| TABLE A - Council s92 matters 14 April 2021 | Applicant Response 17 June 2021 | Council Review 1 August 2021 | Council Review of Responses dated 23/8 + 31/8 |
| Contamination Specialist Input (Vaughan Turner) | | | |

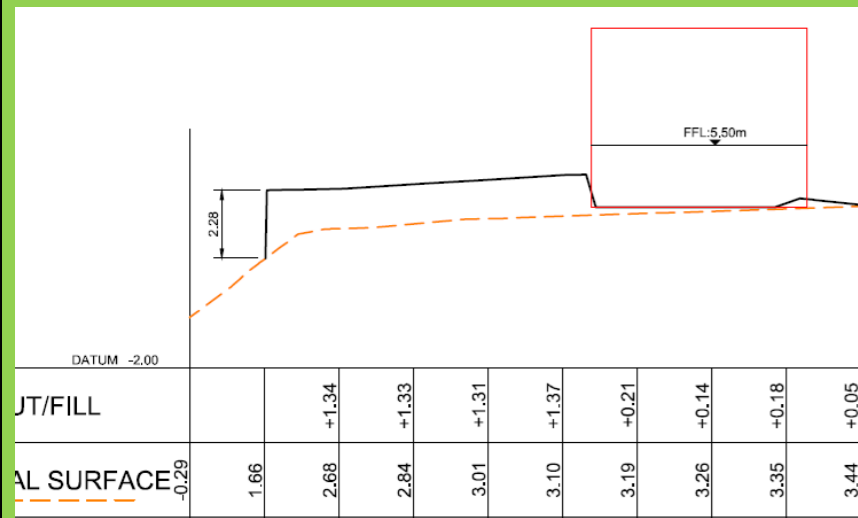
2. The comment provided for E7.6.1.10 (1)(d) is as follows (highlighted in yellow):

(d) diversions for no longer than 10 days; or
Any groundwater diversion as a result of the apartment building basement will be permanent.

If the diversion is permanent, then the PA standard E7.6.1.10 (1) (d) will not meet.

According to the points noted above the applicant needs to revisit their E7 assessment.

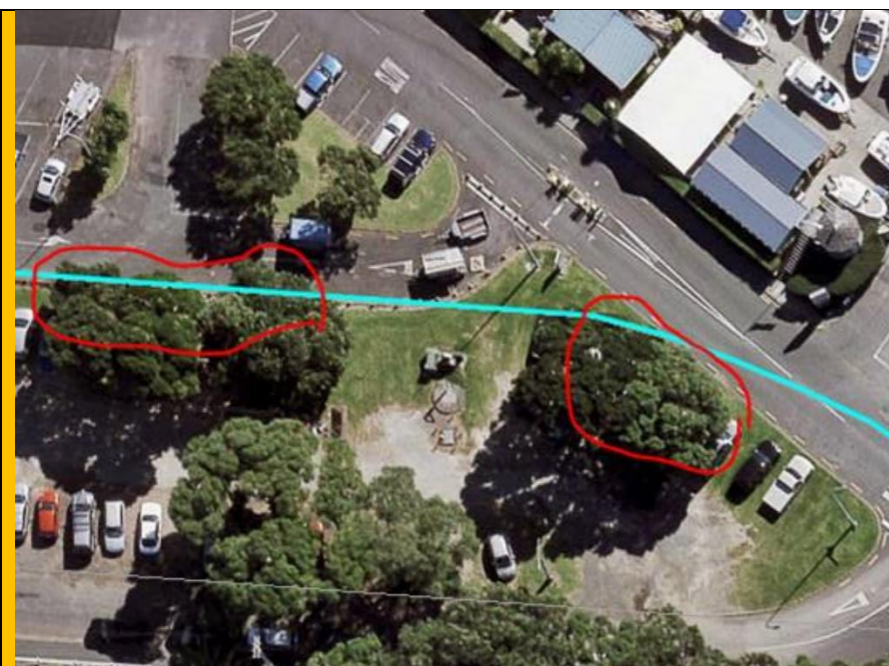
MHWS could be added onto the sections this should clarify things. See snippet below.

- With the new gantries (see yellow in snippet below) and walkway lookouts that connect to these new gantries. It is not clear the works needed to install either, and if the extensions would require footings or are cantilevered over the CMA. The engineering plans identify that the architecture plans are covering this, but there is no detail on this in the architecture set, just these images from the landscape concept. If you can confirm the extent of works and provide detailed drawings of what is sought. It is not clear if there will be access control at these gantry points there is not anything shown on the landscape concept images, but there is access control at present on site.

Please provide the assessment of effects in relation to this Rule (coastal processes/coastal hazards, coastal ecology, public access, natural character, construction effects, navigation etc)

- As you stated in the S92 response, if the retaining wall is above MHWS, is this within the CEHA? If it is, please provide a site specific coastal erosion hazard assessment related to the proposed retaining wall on land and other structures within the CEHA triggered by the Rule.

sections which should be used to gain a high-level understanding of the proposed topography. As such we consider that showing MHWS on these drawings would imply a certain level of accuracy that is not guaranteed. Reference should instead be made to drawing 222

New plans have been prepared by Airey for the gantry structures – see Attachment 3.1.

Details regarding access control gates have not yet been finalised.

Fig 5: Illustrates an example where habitable rooms at mews level are provided resulting in a wall at the street of 1.6m height which would require the ground floor to be lowered 100mm below the mews level to meet the 1.5m maximum wall height to a Road or Park.

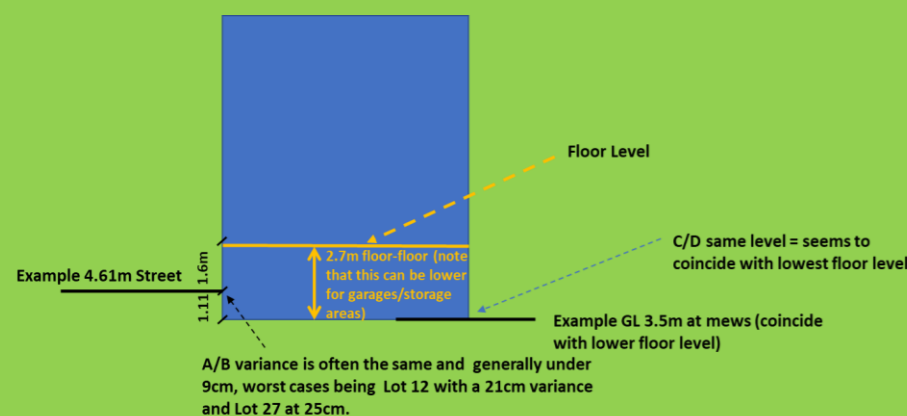
Please provide details to confirm whether a wall height of 700mm be achieved without a split level to the ground floor levels.

It would be useful to test the costs and flooding potential for garage floors to be lower than the level of the mews and provide some practical guidance the probability of this being a design option. Please provide commentary on how low can a garage floor-ceiling height be.

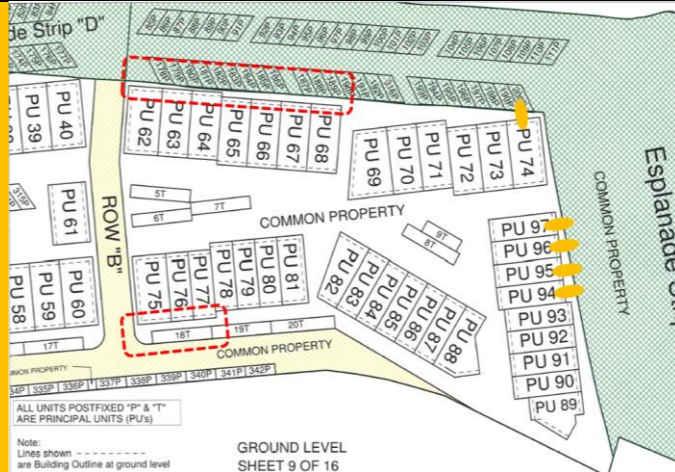
is correct and whether these projections will impinge on the 15m esplanade strip and 7200sqm open space provision on the site.

1. The PU boundaries include the zone of projections, with this covered in the Interpretation section of the Design Manual: Note In.5; and Figure In.1.
2. The only exception is that as identified by R2.14, some units may include steps within the common property, being those lots identified in Appendix 1 Table 2, and for avoidance of doubt recorded also in R2.14 (a). The lowest stair riser is required to be set back 450mm from the back of the footpath.

be located on or over common property and will not extend into the esplanade strip.

| | |  <p>Above: Steps Yellow, Red outline relates to potential balcony overhang and its effects on pedestrian amenity.</p> | |

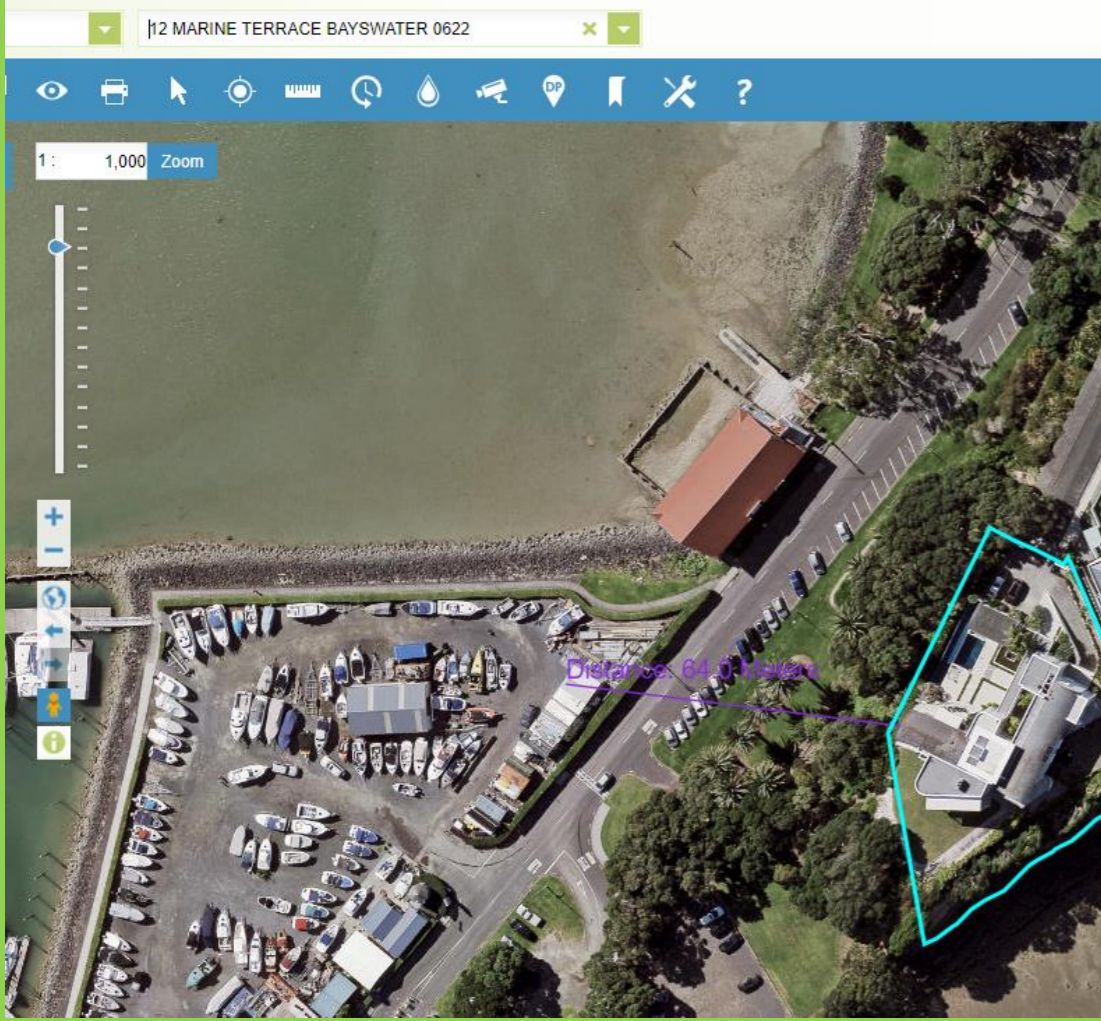
However, there are still concerns that balconies and steps may intrude into the esplanade strip, which would be a planning issue, the effects of these on the western foot pavement which extends Sir Peter Blake Parade also needs to be considered. The key areas which need confirmation are illustrated below, in particular the need for sufficient space to accommodate the steps and footpath?

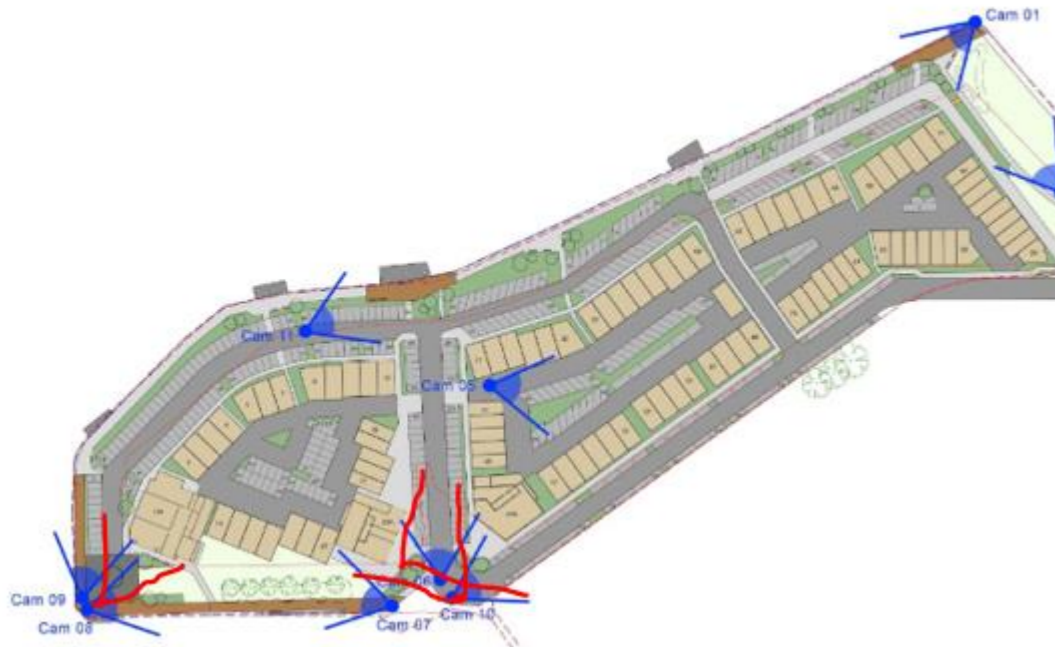
Note: It is recommended that the applicant consult with Auckland Transport regarding the best location for access points through this retaining wall along this boundary.

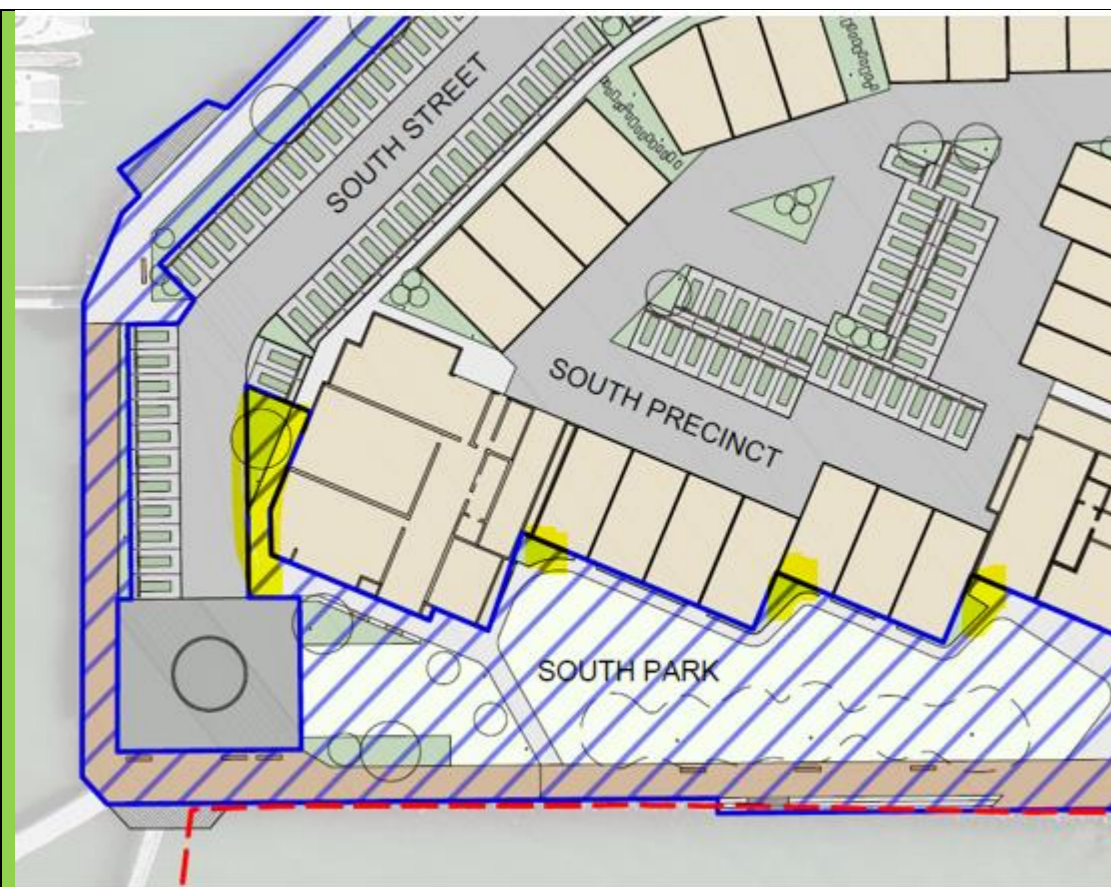
e) The Boat Trailer parking is identified as 1T to 20T principal units. Who will own these 20 principal units? It is understood these are meant to be accessible to the general public for car and trailer. Please clarify what legal mechanism will secure that access and for those spaces located on common property 2T to 9T what legal access arrangements need to be included to ensure access?

f) All berth holder, trailer parking and visitor parking are given an individual principal units. Can you confirm why this is the proposed? Given it does not occur at the moment on site. Why is this necessary to be able to lease them to the berth holders and tenants of the commercial in terms of a licence lease or licence to occupy? Do this parties need to pay an annual lease? For the trailer parking it was understood that these were to have free public access is that not the case?

We prefer to show carparks as PUs, they remain ancillary to the development are easier to manage, allocate or transfer within the development.
This also gives the marina company the same control that exists on site.

All parking - public, marina berth holders and unit owners is shown as PUs so they may either be owned by unit owners, or the Marina management company who will control the use of same.
We prefer to show carparks as PUs, they remain ancillary to the development are easier to manage, allocate or transfer within the development.
This also gives the marina company the same control that presently exists on site.
